Objection number**OBJ32**
Objector's Name Steven Patterson, Sustrans
Date submitted..... 10 March 2015
NIMVO plot numberN/A

TransportNI has considered the correspondence in the above objection and responds as follows:

1. **We wish to object to the draft Orders for the York Street Interchange. We object on the following basis:**
 - i. **The Proposed Scheme fails to meet the requirements for the provision of walking and cycling, as set out in the Belfast Metropolitan Transport Plan 2015.**
 - ii. **The Proposed Scheme fails to meet the aspirations/objectives for cycling, as set out in the Department for Regional Development's Draft Bicycle Strategy 2014.**
 - iii. **The Proposed Scheme fails to give due recognition to the significant impact on walking and cycling that the current relocation of the University of Ulster will have.**

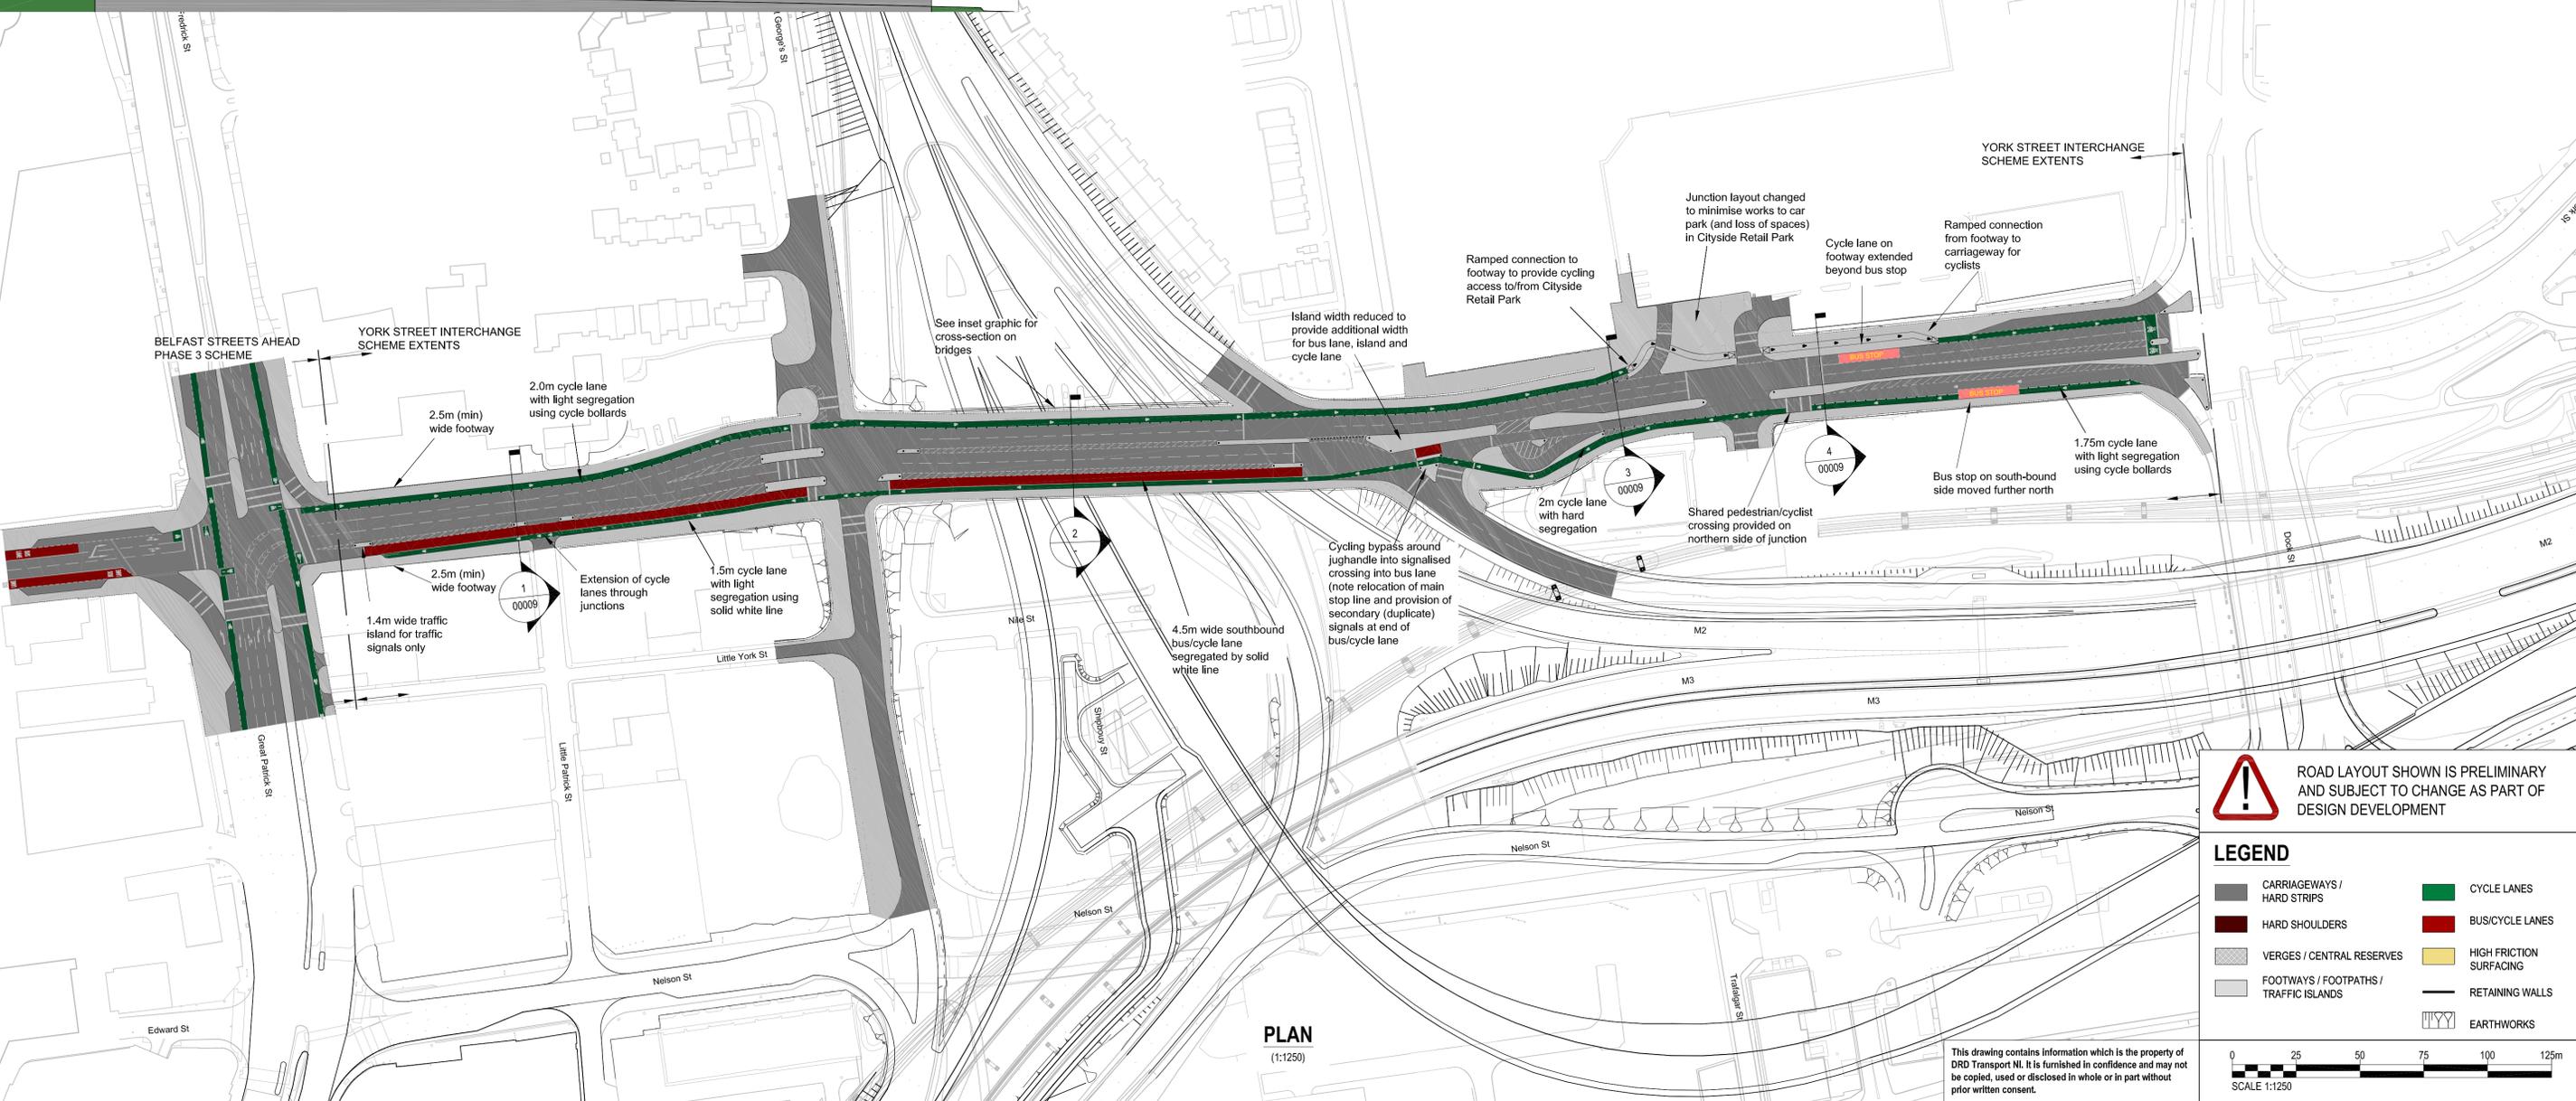
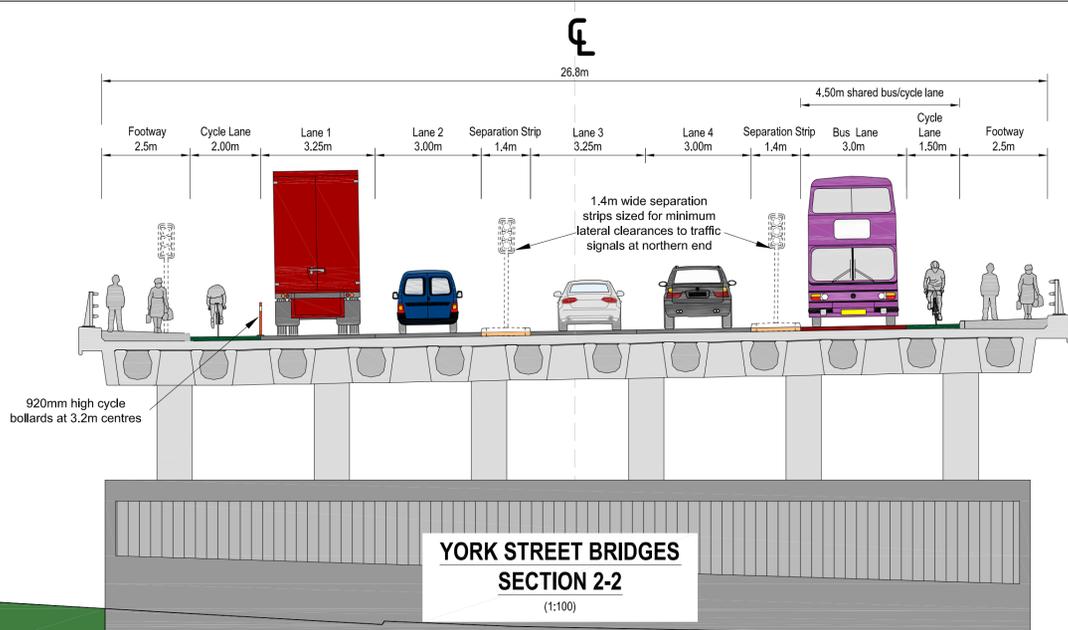
Cyclists are at their most vulnerable at road junctions and the proposals which include advance stop lines up to 5 lanes wide are impractical. Much more thought needs to be given to the design of all junctions, including Danish style two phase turning for cyclists.

We are extremely disappointed with the cycling and walking infrastructure being proposed and we have set out our rationale for objecting. We are, however, convinced that the situation can be rectified through the redistribution of road space and redesign of junctions. These changes can, we believe, be accommodated within the general layout of the proposed scheme, for example, without the need to widen the York Street Bridge.

- a) As you will be aware, following the statutory consultation period, TransportNI has further engaged with Sustrans and DRD Cycling Unit to review provision for all non-motorised users on York Street. All aspects raised by your response have been considered in developing a revised proposal.
- b) We enclose two drawings illustrating the revised proposal for your information. The revised proposal will be available for discussion at the upcoming Public Inquiry.

- a) As you will be aware, following the statutory consultation period, it is noted that TransportNI has further engaged with Sustrans and DRD Cycling Unit to review provision for all non-motorised users on York Street. All aspects raised by this response have been considered in developing a revised proposal.
- b) The revised proposal will be available for discussion at the upcoming Public Inquiry.

Drawing Title
YORK STREET INTERCHANGE
TYPICAL SECTION
REVISED NMU PROVISION
PRE-INQUIRY

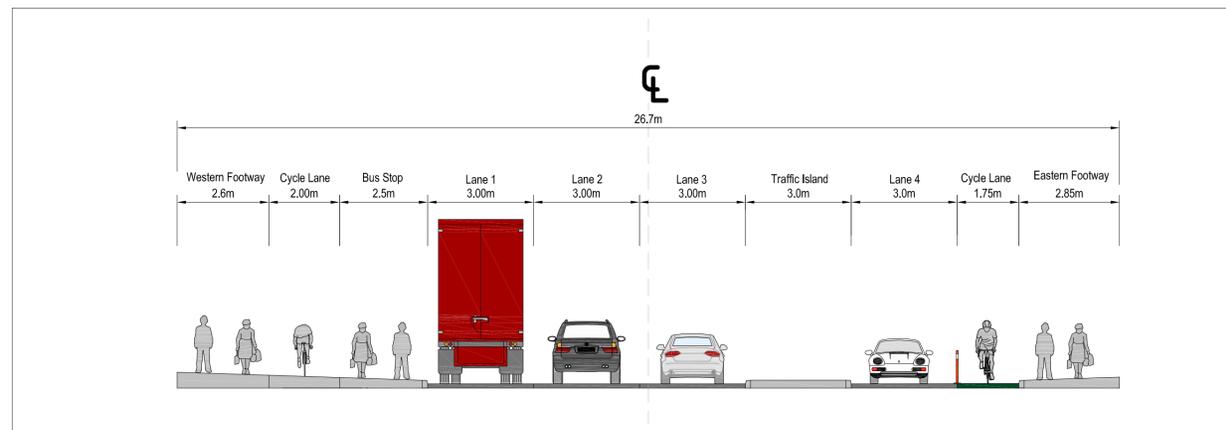
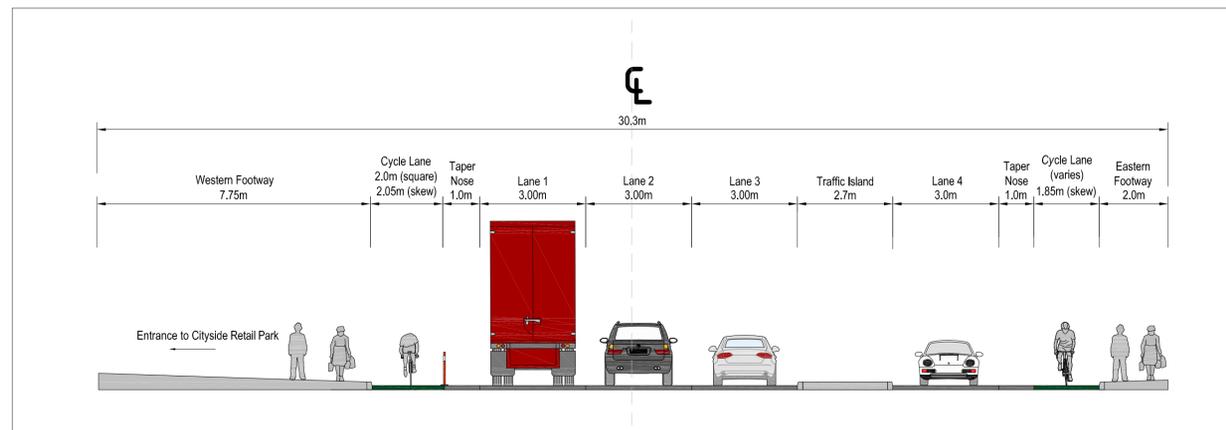
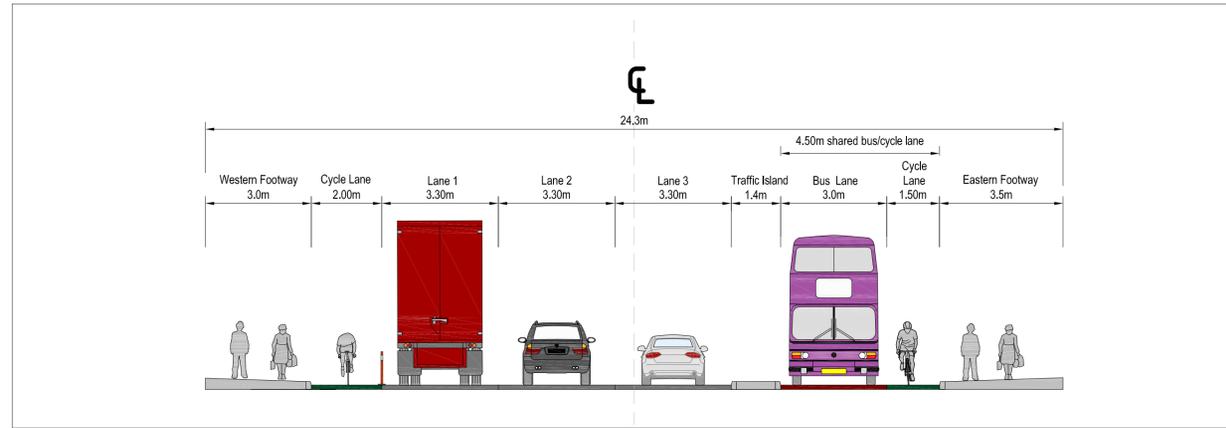
Out of a total width of 27.2m only 1.5m has been allocated specifically for cycling, while 3.2m are allocated for separation strips and 6m for footway.

We would contend that the total space available could be reallocated to provide two 2m wide segregated cycle lanes and meet all the other spatial requirements.

- a) As you will be aware, following the statutory consultation period, TransportNI has further engaged with Sustrans and DRD Cycling Unit to review provision for all non-motorised users on York Street. All aspects raised by your response have been considered in developing a revised proposal.
- b) We enclose two drawings illustrating the revised proposal for your information. The revised proposal will be available for discussion at the upcoming Public Inquiry.
